NUCLEAR REGULATORY COMMISSION

Title: Advisory Committee on Reactor Safeguards
Radiation Protection and Nuclear Materials
Subcommittee Meeting - Open Session

Date: Wednesday, August 19, 2015

Seismic Analysis Results

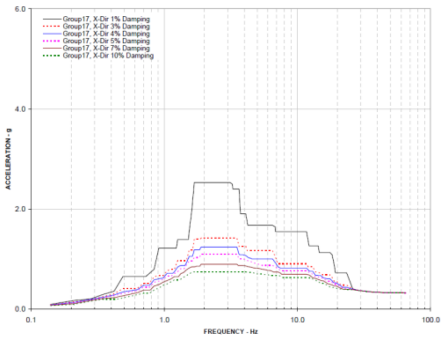
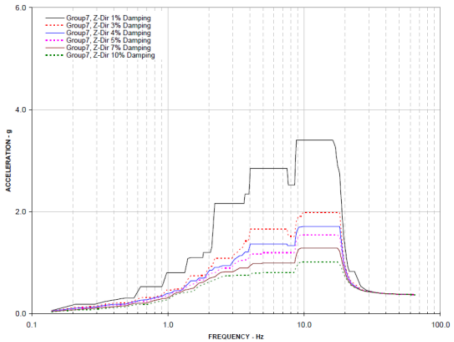
And what's the modeling under that, that let's us kind of decide the snow's melting, it must be melting almost as fast as the rain's coming, because the calculations don't show a big effect. And I'm seeing big effects too.

22 The results from the seismic analysis
23 were in structure response specter were developed for
24 various damping values in the horizontal and vertical
25 directions for critical location to the building.

1 These are just shown on the slide here are just two
2 samples of the response specter that were developed.
3 And then maximum seismic accelerations
4 were developed at critical locations in the building.
5 For instance, the center of the upper roof came up
6 with 0.31 g's horizontal and 0.9 in the vertical due
7 to the flexibility of the roof.
8 And the center of the shear walls gave us
9 0.41 g in the horizontal due to the flexibility of
10 the shear walls in the outer plan direction. And
11 then 0.31 g in the vertical direction.
12 The structural analysis model determines
13 the adequacy for seismic as well as other hazards.
14 As I mentioned, there's a 3D finite element model of
15 the SHINE facility structure using -- most grade are
16 using SAP2000.
17 The reinforced concrete reinforced rate
18 -- the required concrete reinforcement ratio was
19 calculated from the SAP2000 force and moment outputs.
20 The model consists of all the safety-related areas of

Fire Protection Process Flow Diagram

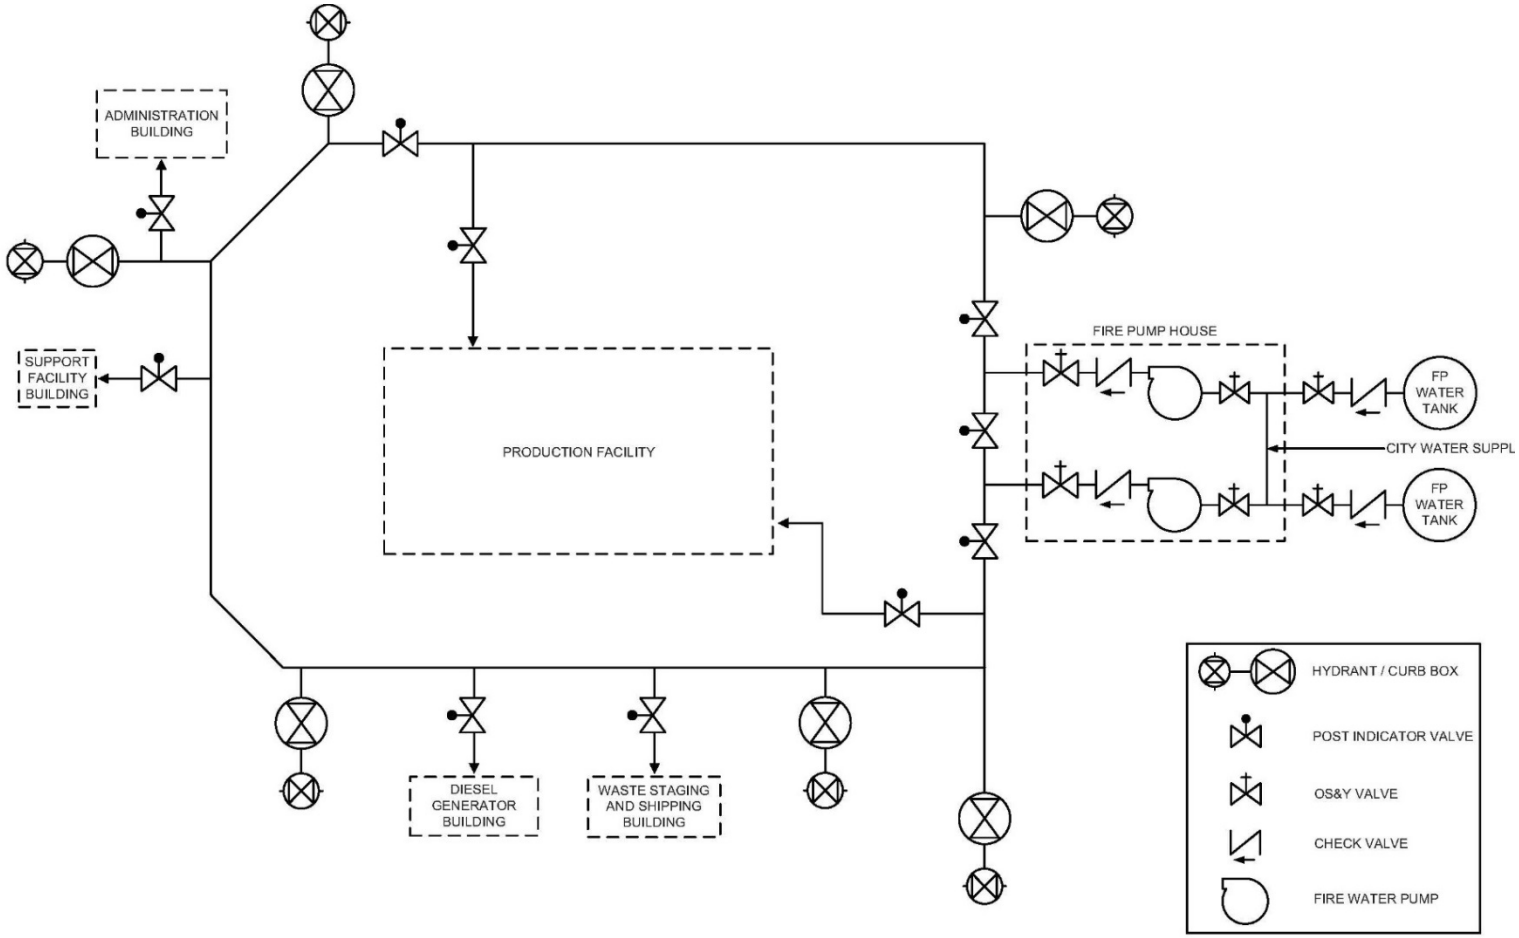
MEMBER BALLINGER: I have--I think it's a dumb question, but I'm looking at that schematic. Is that a schematic or is it actual piping, P&ID diagram? In other words, there's no isolation valve; if something happens to that cross connector between the two tanks, we're done for. In other words, if you develop a hole, that pipe, that cross connect pipe fails, there's no way--

MEMBER STETKAR: A lot of the schematics don't show manual isolation valves at this stage in the game; that's sort of--

1 MR. ALDIERI: I'm sorry. I've spoken
2 so--last slide if I may is--
3 [Off the record comments]
4 MR. ALDIERI: The last slide is fire
5 protection process diagrams, and this is a very
6 typical site layout, you have the two independent
7 water tanks, we do share the city water supply.
8 Again, they're all cross connected where the two pumps
9 are cross connected with a typical ring header, so if
10 you have any short leg out, or hydraulically suctioned
11 out, you can always provide water to the plant from
12 two different directions, so you're always assured in
13 providing water supply. Again, you'll see
14 sectionalized valves, again, that are just spaced
15 such that you can always lose one leg and provide the
16 alternate means. And then hydrants, again just
17 variously located around based on a general site
18 layout. One question was asked, why two tanks, we
19 have a city water supply. If during the later stages

20 we verify that there's enough flowing pressure, that
21 can be revisited, but this is a typical template
22 design for meeting most standard designs if anybody
23 has any questions on that.
24 MEMBER STETKAR: I had one more question.
25 It doesn't have anything to do with hardware or

MR. ALDIERI: It's got the big picture point of view, correct. And in fact, once you get the final design, one tank may go away, so it's just kind of representative of a site layout. Any other questions?

Aircraft Hazard Analysis Update

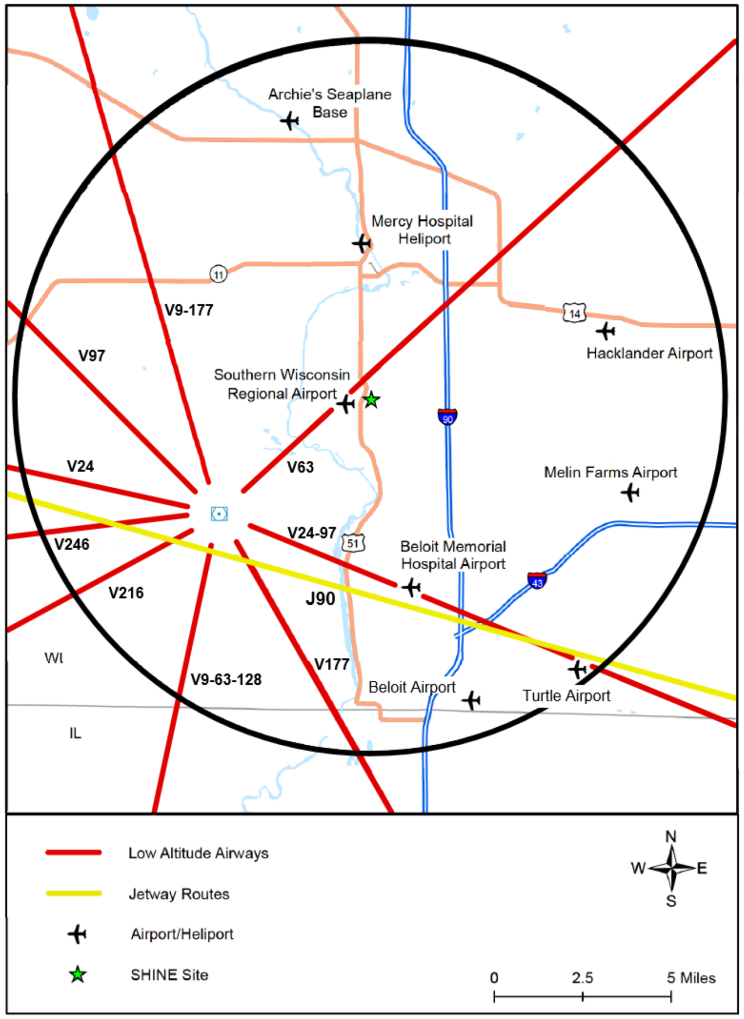
The next five slides are considering our aircraft hazard analysis. This is a updated version of PSAR Figure 2.2-2. We used low and high altitude charts from the FAA to construct this because the airways, the low altitude airways converge on the radio beacon, a navigational aid which is offset several miles from the airport. So there is one airway that is almost directly over our site.

- Low altitude airways and jetway routes within 10 miles of the SHINE facility are shown.
  - SHINE will revise PSAR Figure 2.2-2 to reflect the low altitude airways and jetway routes shown.
